T-12523

TRANSFER APPLICATION MAP
 Certificate 41697
 Sections 29, 30, 31 & 32, T15S, R5W, W.M., and
 Section 36, T15S, R5W, W.M., and
 Sections 5, 6, 8, 17, 20, 21 & 29, T16S, R4W, W.M., Lane County
 City of Junction City

In the Matter of Transfer Application	)	FINAL ORDER APPROVING OF AN
T-12523, Lane County	)	ADDITIONAL POINT OF
	)	APPROPRIATION AND A CHANGE IN
	)	PLACE OF USE

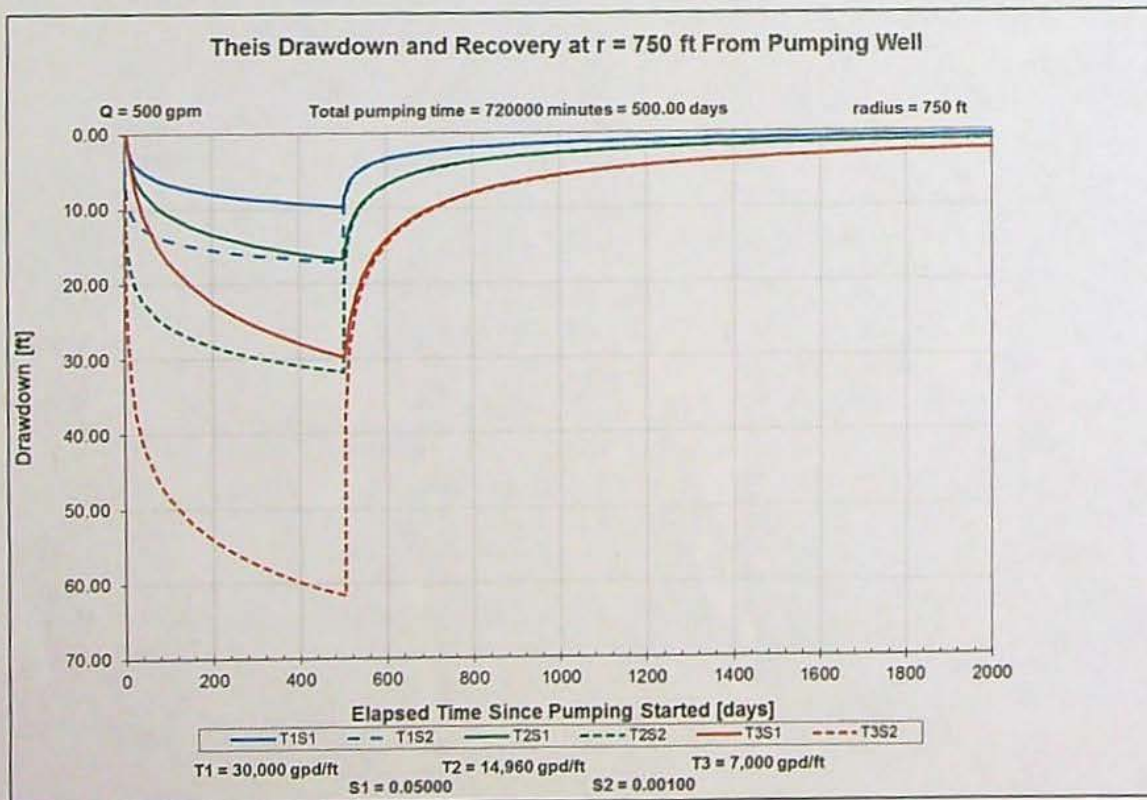
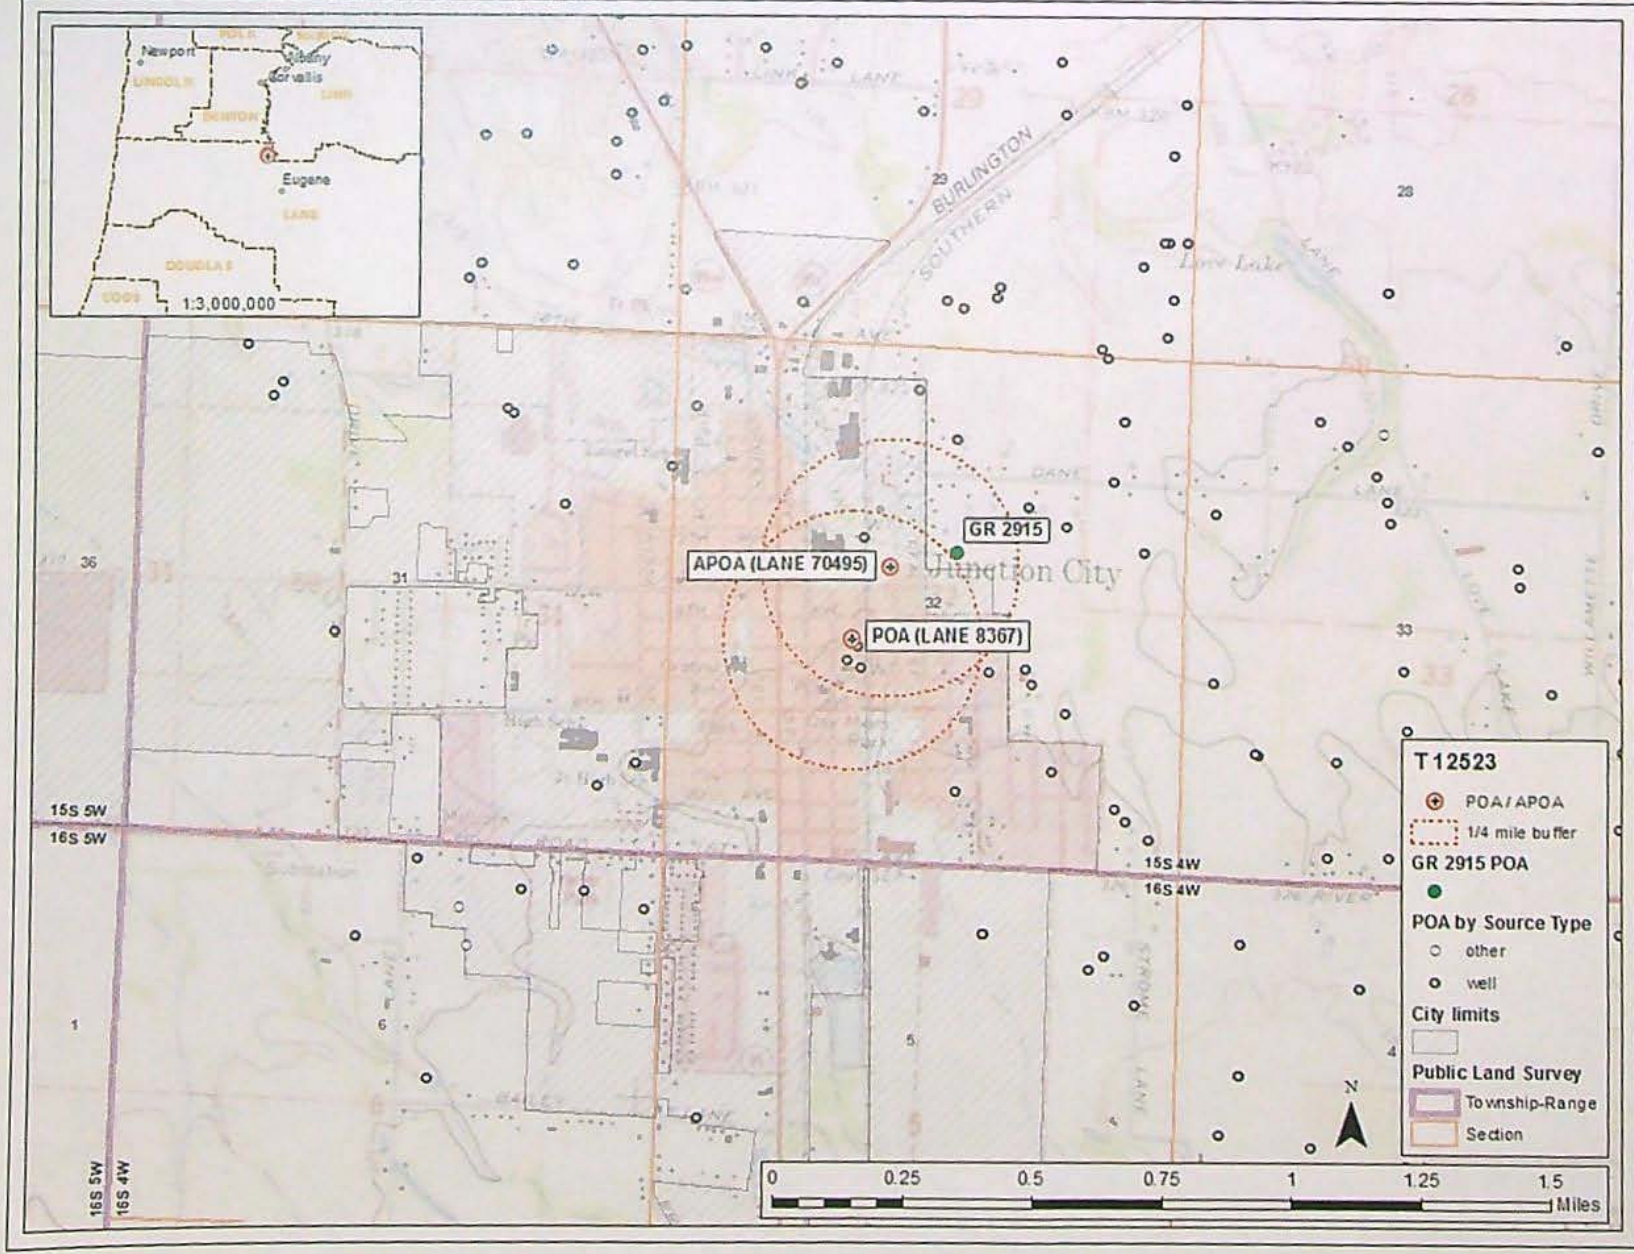
4. a) Will this proposed change, at its maximum allowed rate of use, likely result in an increase in interference with **another ground water right**?
☒ Yes ☐ No Comments: There are several mapped POAs in the vicinity of the POA and proposed APOA but all but one are owned by the city of Junction City so interference will not be considered for those. There is one claim, GR 2915 for irrigation of 15.2 acres, that is within 750 ft of the proposed APOA (~1400 ft from original POA) and may be impacted by the proposed change. GR 2915 is senior to Cert. 41697.

☐ Yes ☒ No Comments: The proposed APOA is only slightly closer to the nearest surface water source, the Willamette River, and any additional interference would be insignificant and immeasurable.
